Addendum No. 3

Project Name: NECSD – New CTE Building

CSArch Project No. 108-2303

1 ENLARGED FLOOR PLAN - AUTO TECH SHOP
A613 1/4" = 1'-0"

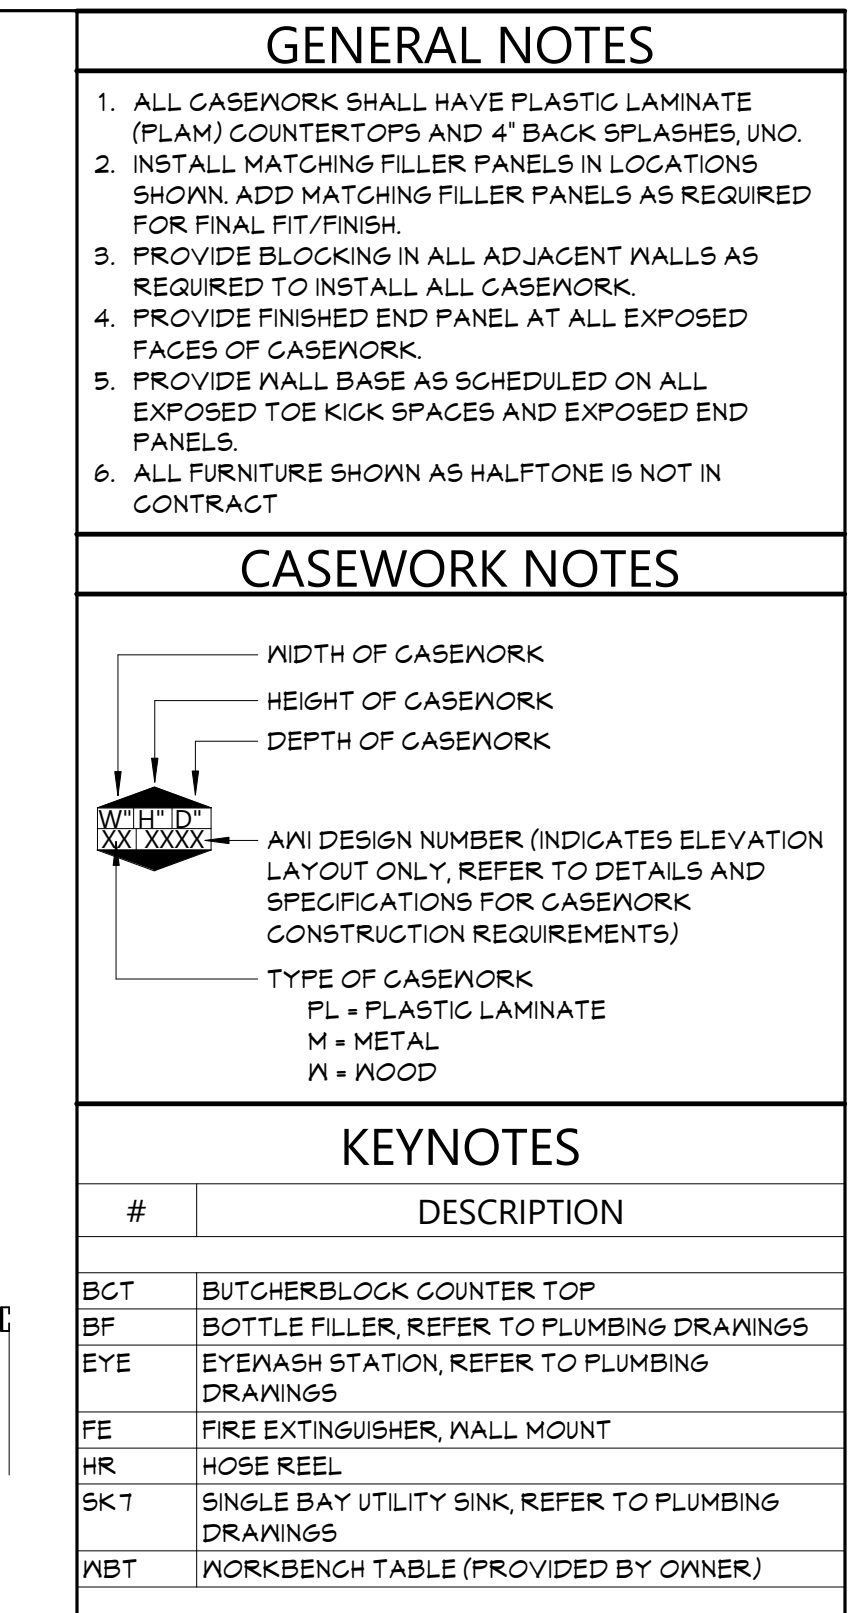
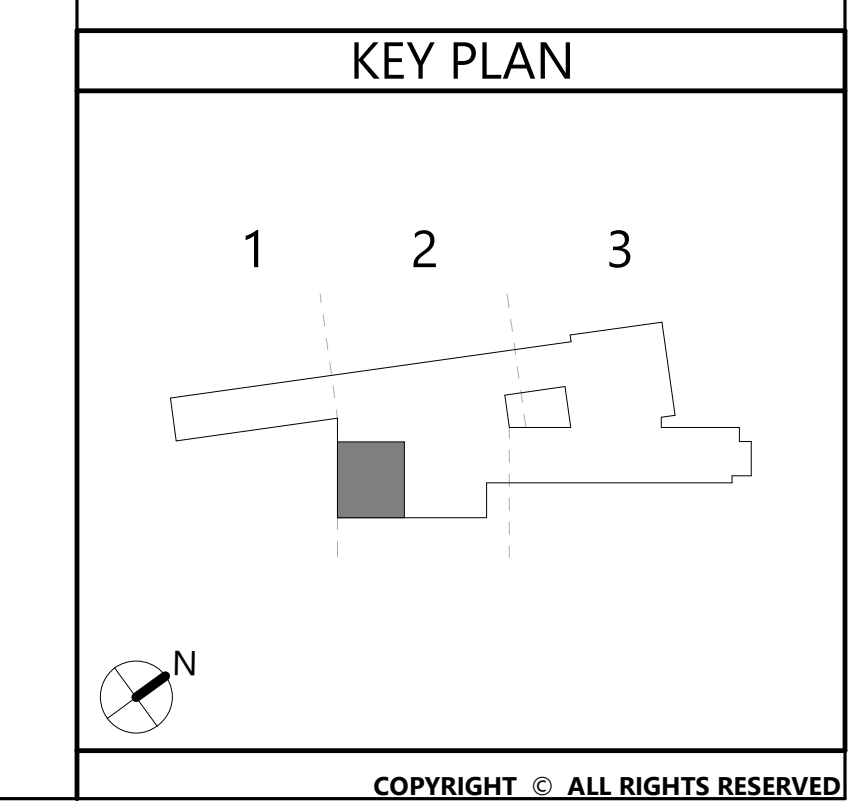
| 10 | A | Equipment List | <p>The equipment list is understood but incomplete. It is fine for equipment positioning and electrical requirements, but there is specific information missing that is required for an accurate quote. There are accessories for the brake lathe and the wheel balancers that aren't included on the plans but are typically required to be included in the price quote. For example, the wheel alignment system, described on the plan as "head unit", HE421, is incomplete. There are several configurations available for a wheel alignment system. HE421 just describes the measuring sensor type, but does not include the console which houses the PC, monitor, printer, etc. There are options for the wheel alignment lift, RX12 that might be beneficial in a student learning environment but are not indicated. Please review the contractor required equipment lists and clarify which accessories should be included in the bid.</p> | 4/30/2024 | Worth Construction Co., Inc. | <p>Provided as part of addendum #3.</p> | Yes | A604, A613, A615 | | Add #3 |

1 INTERIOR ELEVATION - GENERAL CLASSROOM
AF002 1/4" = 1'-0"

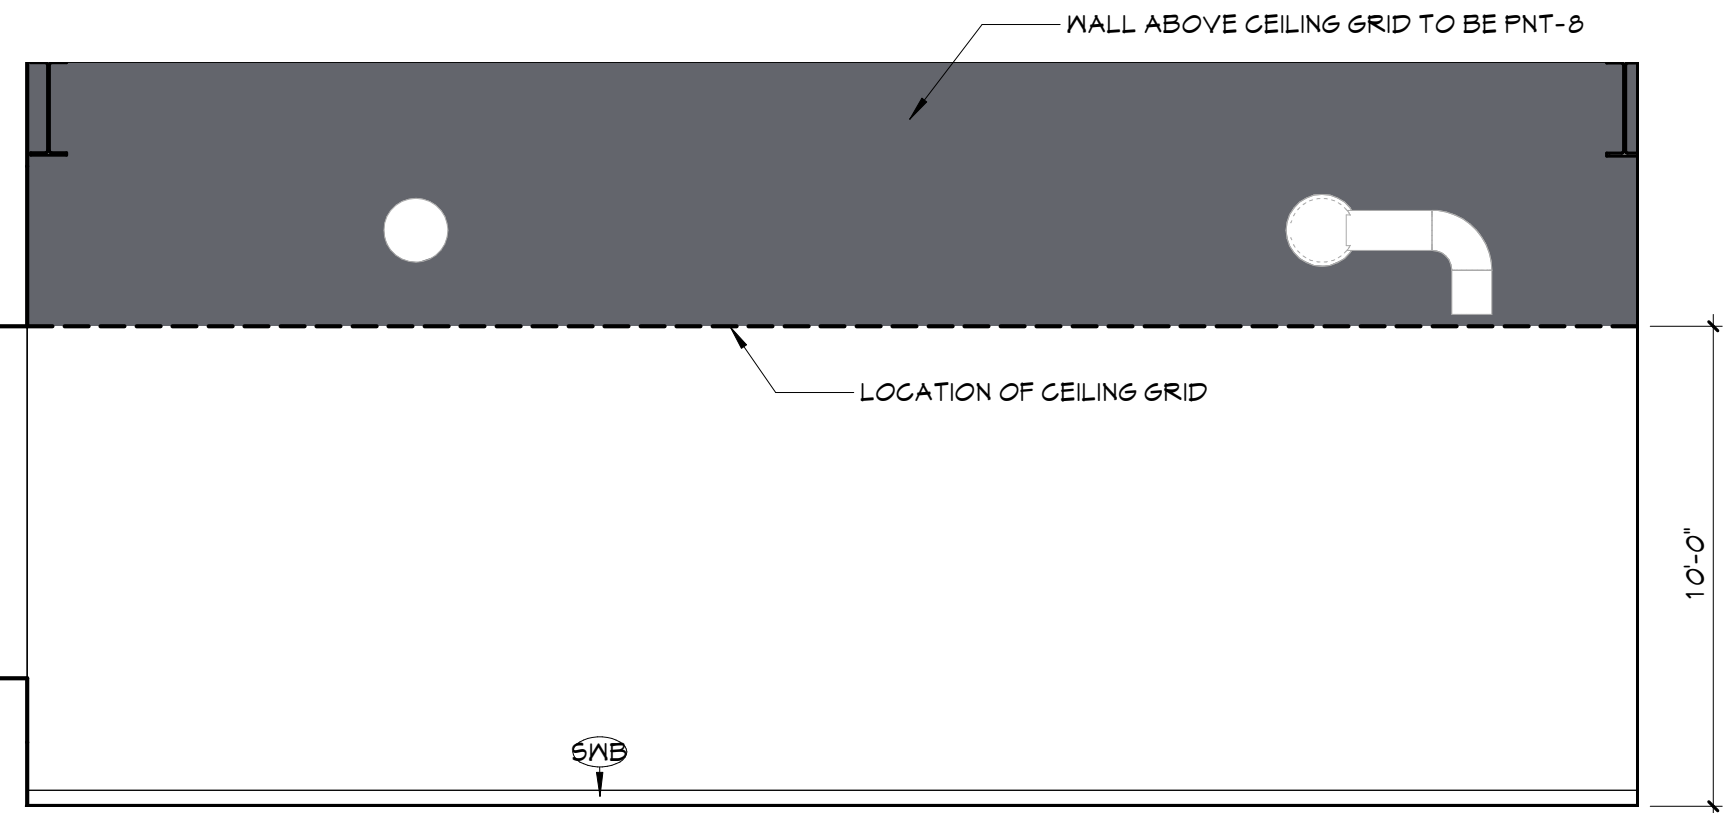
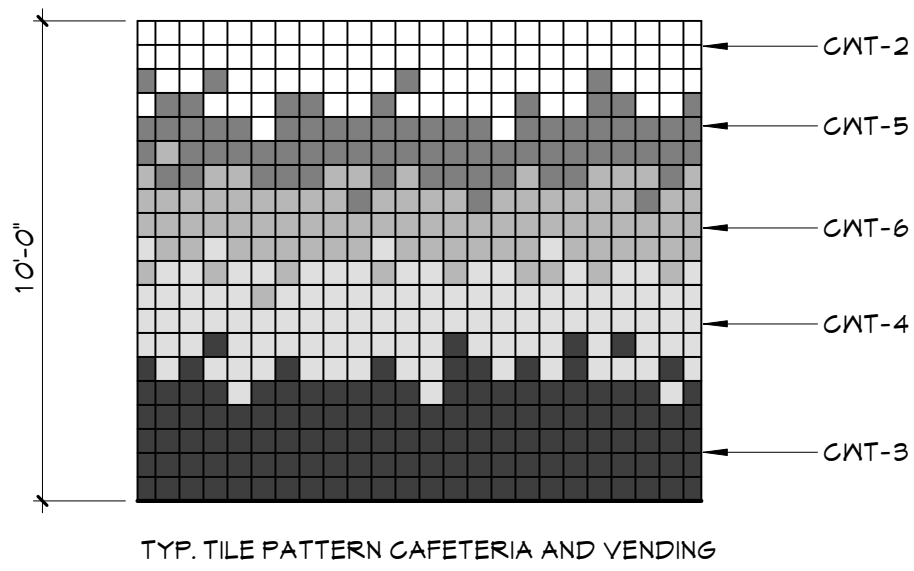
| 39 | AF | Division 9 | RT-1 Rubber Tile for intermediate landings; Marbleized is not available in 24" x 24" and not available in 3.5mm thickness, please advise. | 5/9/2024 | Rizzo Companies Worth Construction Co., Inc. EW Howell Construction Group | Revised as part of addendum #3. | Yes | AF002 | 096500 | Add #3 |

| 41 | AF | Division 9 | Sheet Vinyl Base HMB-1 Base is 4" High ? | 5/9/2024 | Rizzo Companies Worth Construction Co., Inc. EW Howell Construction Group | Revised as part of addendum #3. | Yes | AF002 | | Add #3 |
| 43 | AF | Division 9 | Vent Cove Base 4" in section 096466-3 para 2.5A and RB-2 is 6" on Drawing AF002, please advise 4" is required for this bid scope. | 5/9/2024 | Rizzo Companies Worth Construction Co., Inc. EW Howell Construction Group | Revised as part of addendum #3. | Yes | AF002 | | Add #3 |

| 54 | AF | Division 9 | Corridors 1st - 3rd floor wall base; Elevation Drawings A631-635, Details show SWB, Which walls get RB-1 and which get MT-1 ? | 5/9/2024 | Rizzo Companies EW Howell Construction Group | Revised as part of addendum #3. | Yes | AF002 | | Add #3 |
| 55 | AF | Division 9 | Limits of MT-1 Metal Base at Vending 118A on 1st floor and same for Cafeteria 116 ? | 5/9/2024 | Rizzo Companies EW Howell Construction Group | Revised as part of addendum #3. | Yes | AF002 | | Add #3 |
| 56 | AF | Division 9 | Limits of MT-1 Metal Base in Cafeteria 116 ? | 5/9/2024 | Rizzo Companies EW Howell Construction Group | Revised as part of addendum #3. | Yes | AF002 | | Add #3 |

CTE
AF121

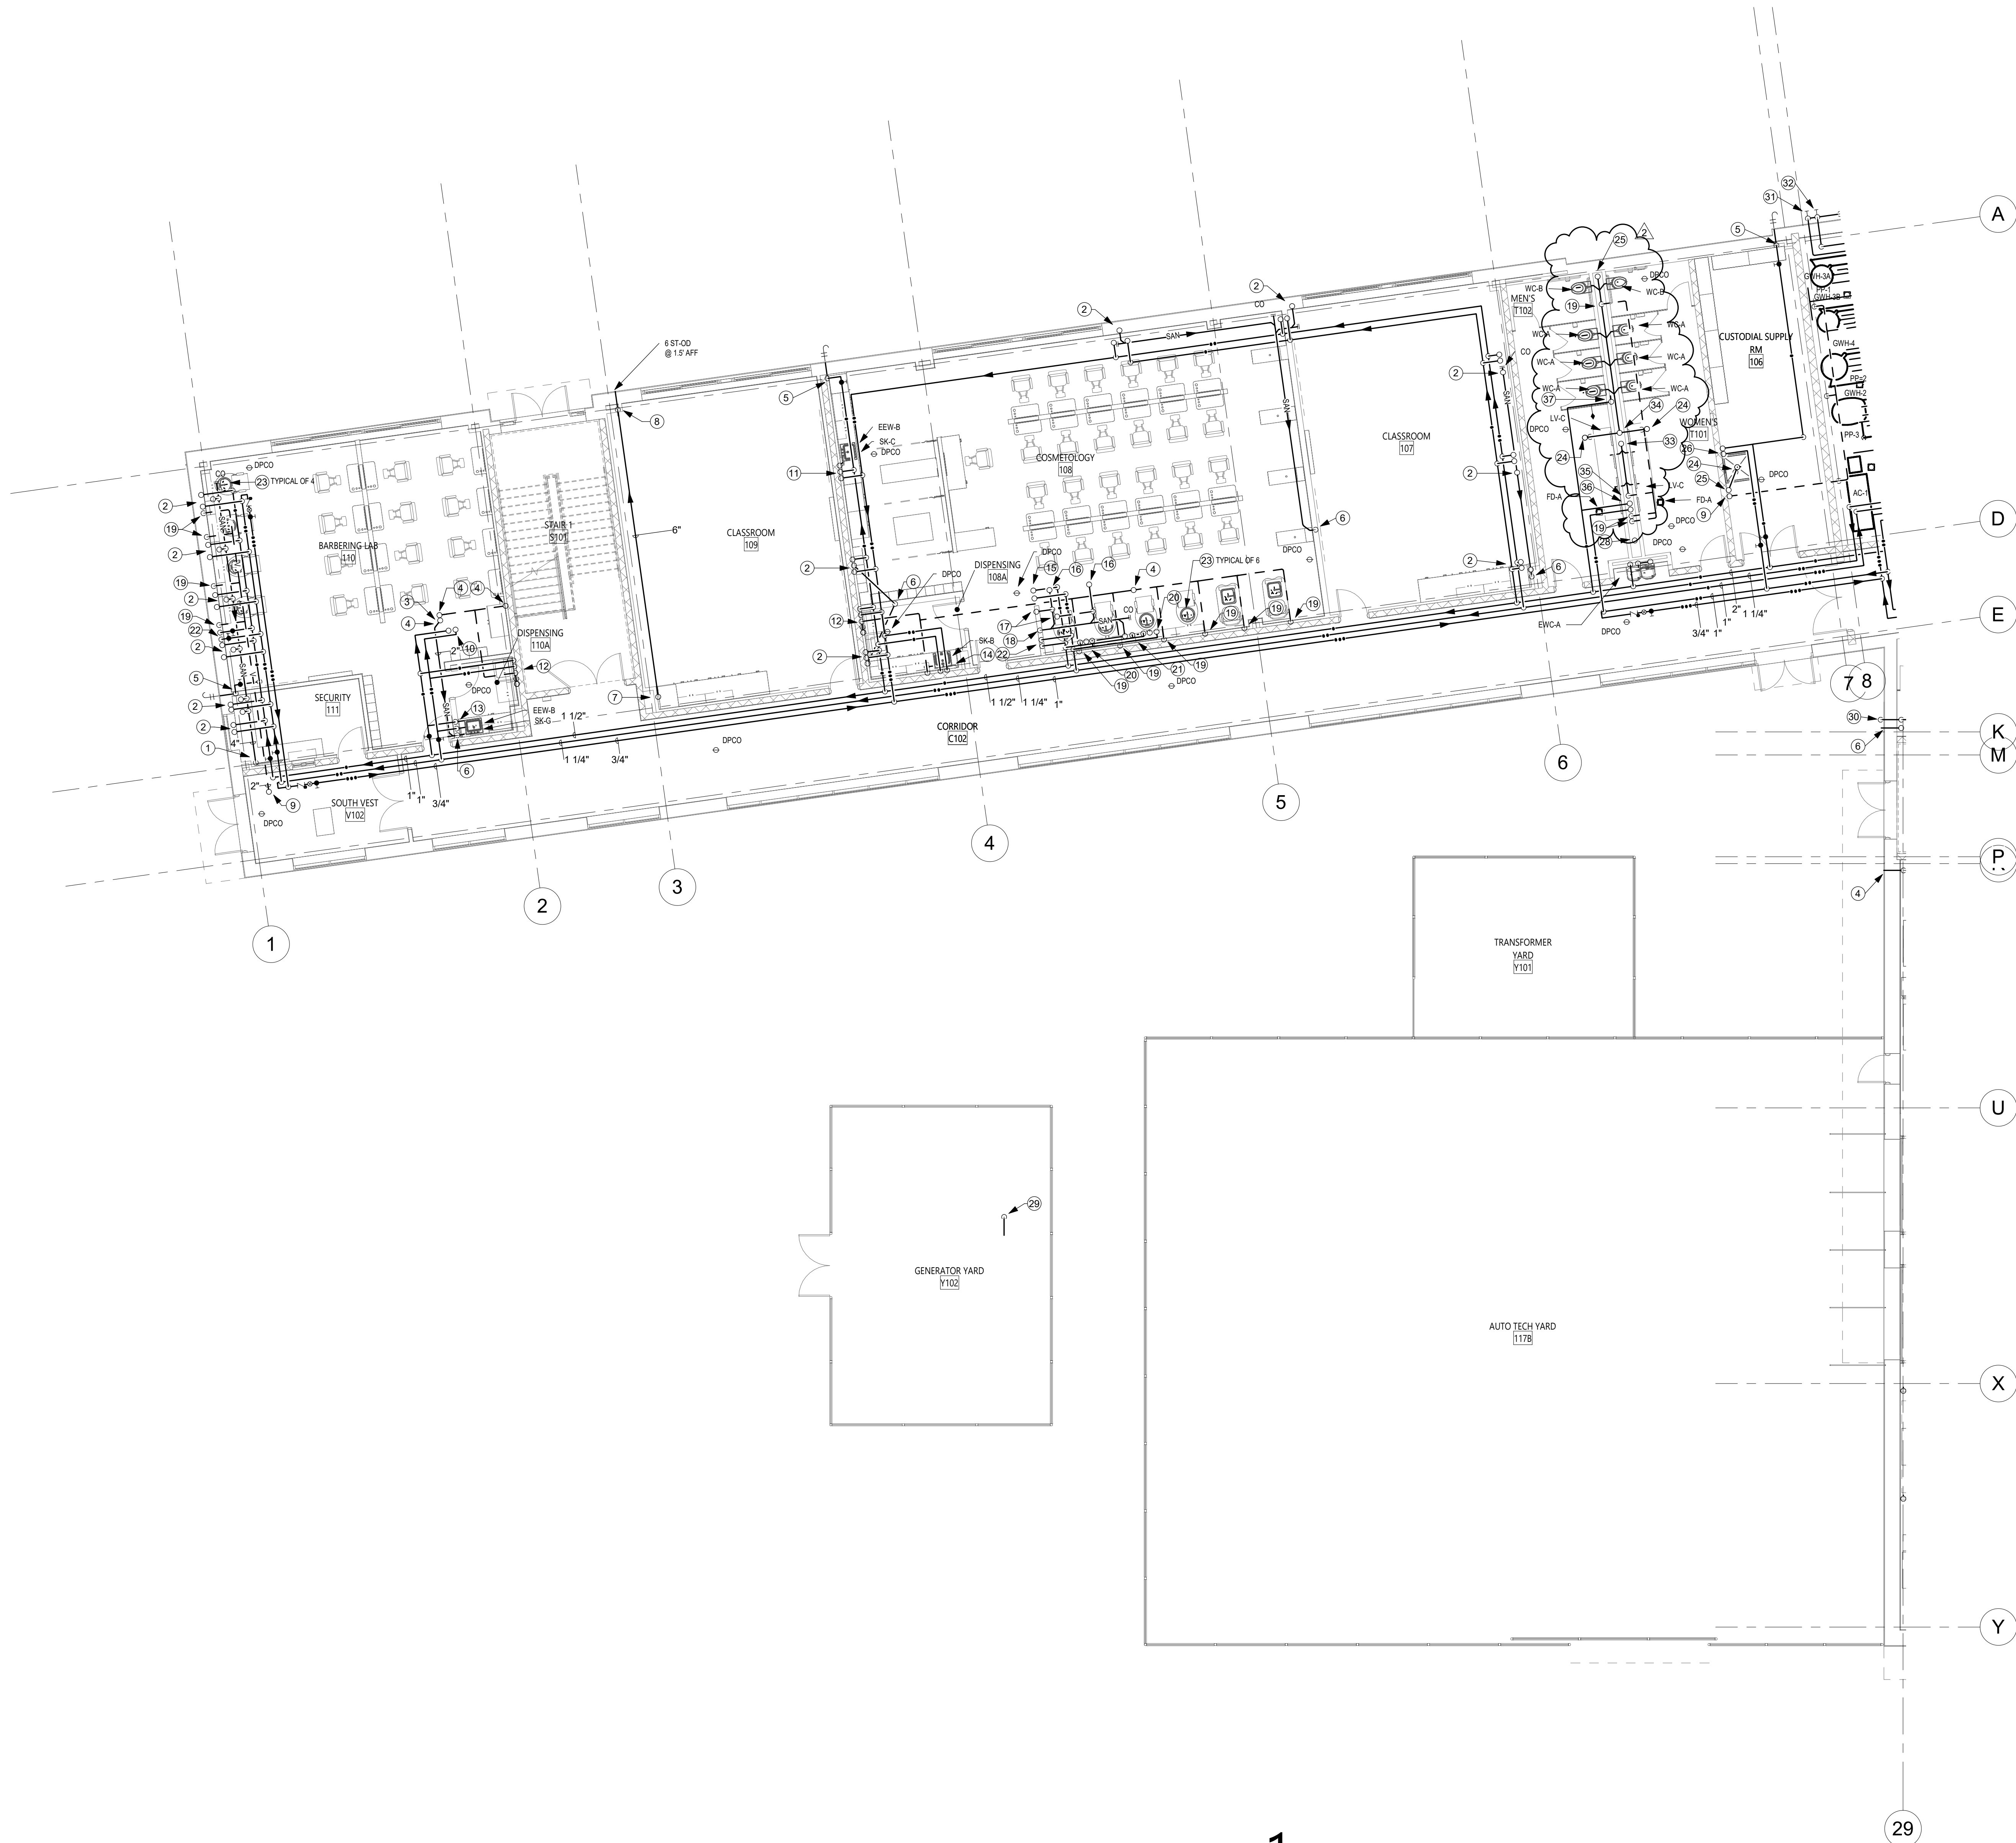
| 59 | AF | Division 9 | HMB Sheet Vinyl to HMB Sheet Vinyl at door threshold, Doors 202A, 202C, 202D; Heat weld seam only, please advise. | 5/9/2024 | Rizzo Companies Worth Construction Co., Inc. EW Howell Construction Group | Revised as part of addendum #3. | No | AF121 | | Add #3 |
